West Elevation Scale 1:100 at A1

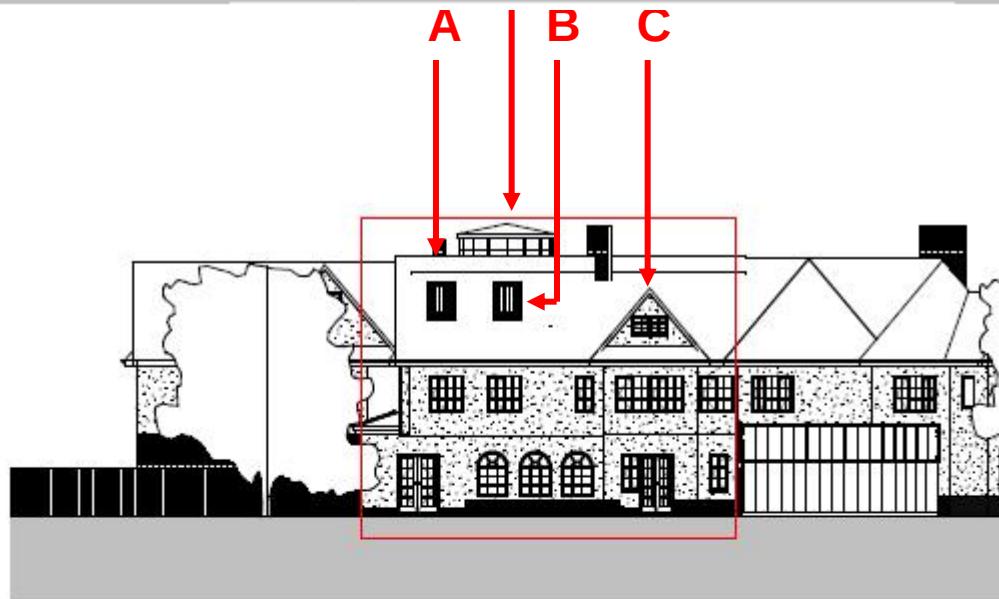
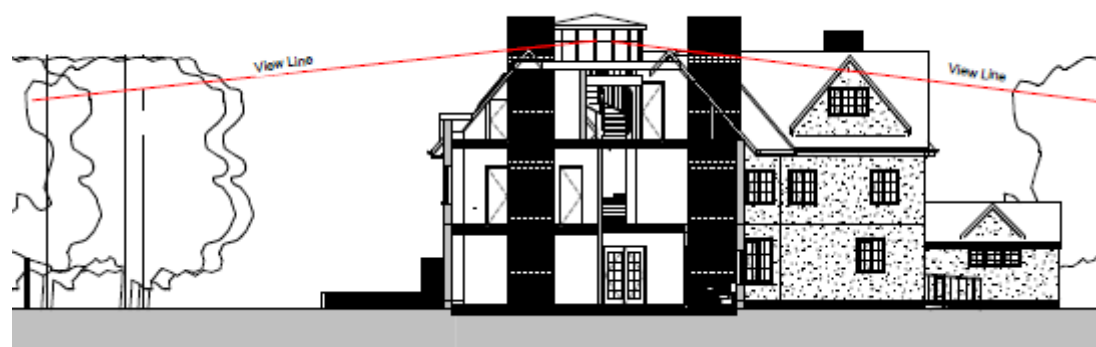
Windows 'A', 'B', 'C' and the Western elevation of the observation POD are significantly higher than the exiting windows on the West elevation of this property and will impact our enjoyment of our back garden by creating direct lines of sight into it.

Proposed window 'A' will overlook our garden, albeit partially obscured by an existing tree on an intervening plot. Given that neither we nor the applicant have direct control over the future of this tree (although believed to be under a protection order no one can guarantee how long it will live) we believe we should assume a 'worst case' that it may at some time be removed giving this window an unimpeded line of sight into our garden.

Proposed windows 'B' & 'C' will have direct line of sight into our garden,

The observation will have direct line of sight into our garden and into (extrapolating the view line shown on drawing A107).

The site plan drawings do not take into account the extension to our property which features an East facing bedroom window and large roof lanterns to living space. Both the observation pod and windows A,B & C will have direct line of sight through these glazed area and are likely to impact our privacy in the house, particularly at night through the roof glazing.

We therefore request that Windows A, B and C and windows to the west elevation of the observation POD be obscure glazed to maintain the level of privacy currently enjoyed in our back garden and bedroom / living rooms.
